ARM1020E Rev1 Errata List

Document number: ARM1020E REV1-PRDC-000685 7.0
Date of Issue: 24th June 2003
Author: Paul Garden
Authorised by: John Cornish

This document describes the known errata in the ARM1020E Rev1.

5.1 AHB Compliance Problem With HLOCK Signal (r1p0, r1p3, r1p6, r1p7)

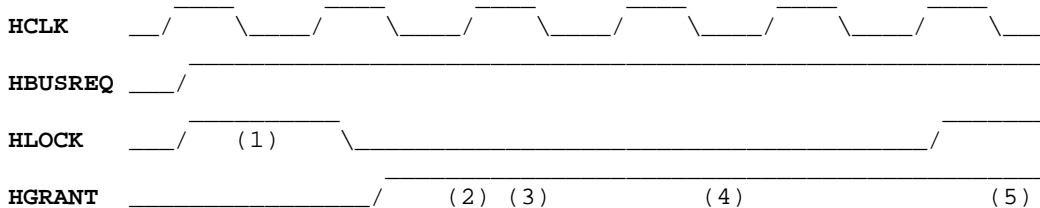
The HLOCK signal may assert for a single cycle near SWPs under very specific circumstances.

The following waveform shows the AHB signals to/from the arbiter. It is worth noting, that the compliance problem is solely related to the communication between the ARM1020E and the AHB arbiter. None of the address/control or data signals are involved.

- (1) HLOCK is erroneously asserted along with HBUSREQ for one HCLK cycle due to the pending swap instruction.
- (2) The AHB verifier complains, that HLOCK is removed before being granted via HGRANT!!!
- (3) The first store out of the Write-buffer takes place.
- (4) The second store out of the Write-buffer takes place.
- (5) The swap takes place as one locked (atomic) transfer.

None required.
